Subject Notes from call with USFWS

# NOTES FROM CONFERENCE CALL WITH USFWS

Subject Comments to Via Verde Project (UNCLASSIFIED)

# Via Verde Pipeline Project: 2011 Puerto Rican Broad-winged Hawk and Puerto Rican Sharp-shinned Hawk surveys

Figure 1.

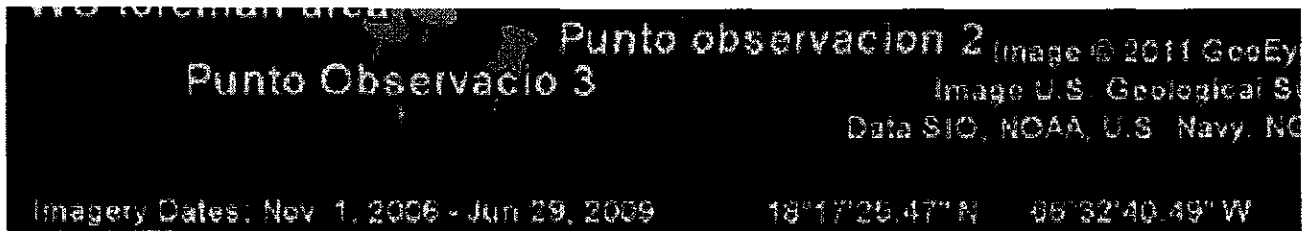
1. Add six new observation points to the endangered raptors study. Focal area surveys can be improved by adding more observation points. Even though the species participate in epigamic and territorial aerial displays during breeding season they do not stay most of the time over the canopy. The suggested points are shown in Figure 1 with the prefix FWS (coordinates of suggested points can be found on attach KMZ file, suggested point can be relocated within the suggested area).

Figure 2. Adjuntas interest area for federally listed plant species.

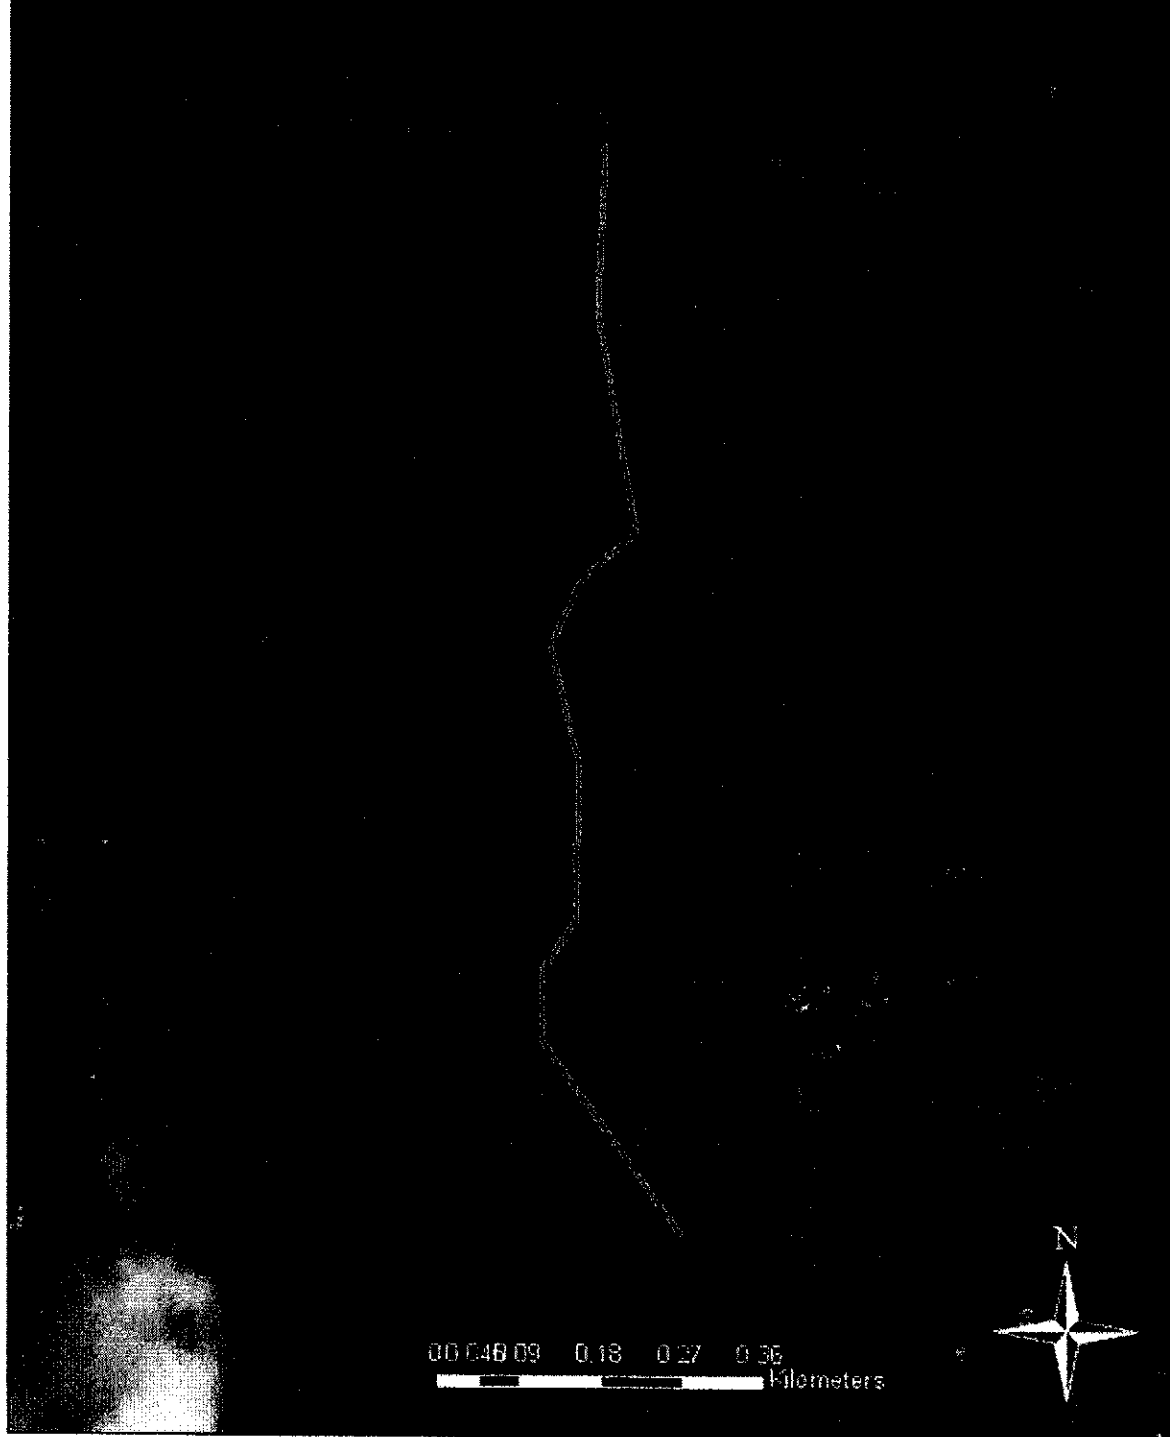
6. The Service continues recommending surveying the Adjuntas area (figure 2). The area of Pico Cerrote harbors a remnant of old forest with some rocky outcrops that can remain as a depository of rare and endangered species. Available information indicates that this area have remained forested for a long period. Ferns dependence on spores for dispersion contributes to the possibility that this area is occupied by our interest species. Despite that the only known population of nogal (*Juglans jamaicensis*) is located several kilometers west of Pico Cerrote, the

Figure 3. Peñuelas interest area for federally listed plant species.

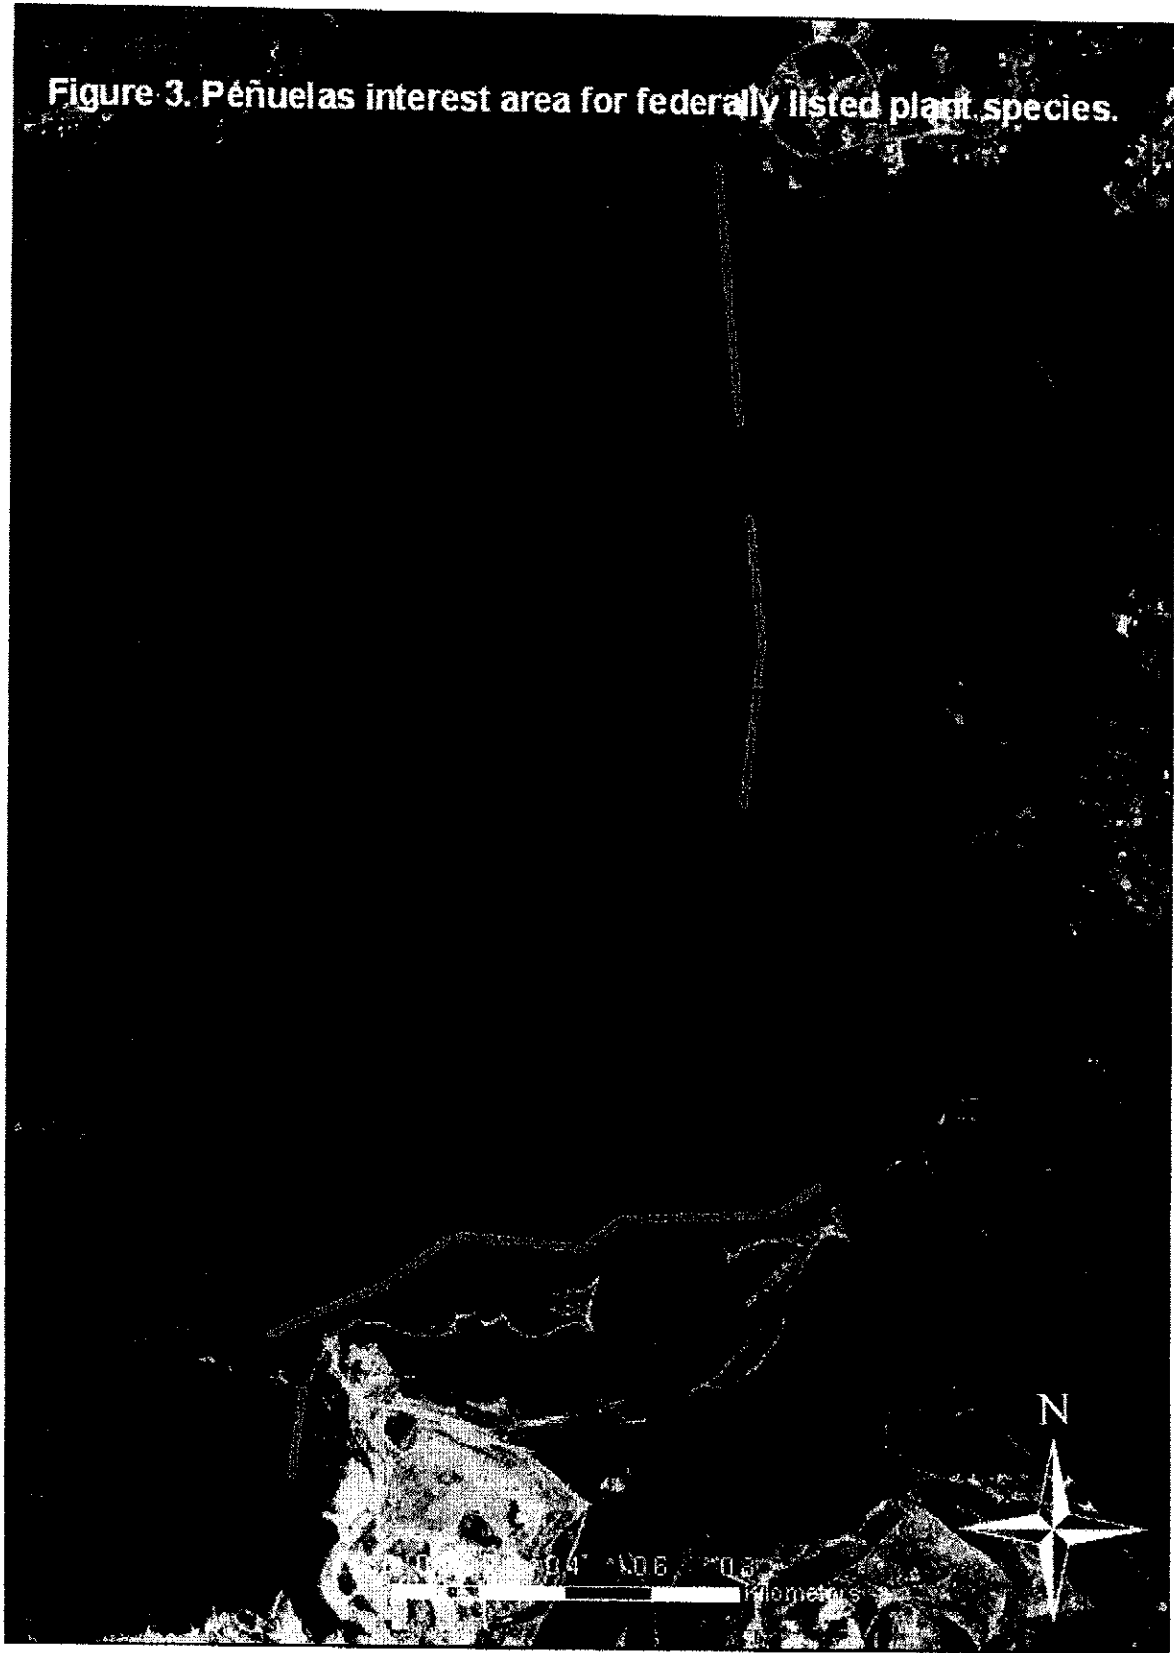
7. The area to be surveyed on Peñuelas does not correspond to the area identified by the Service as a target area. Depicted areas only show a small fraction of the area that the Service recommends to be extensively surveyed. Attached, please find a map that illustrates the areas that require to be surveyed (figure 3).
8. The Service still interested in conducting site visits to evaluate the habitat for endangered species and provide technical assistance to PREPA. The Service recommends that PREPA provide a detailed schedule to allow Service staff to joint Frank Axelrod in the field.
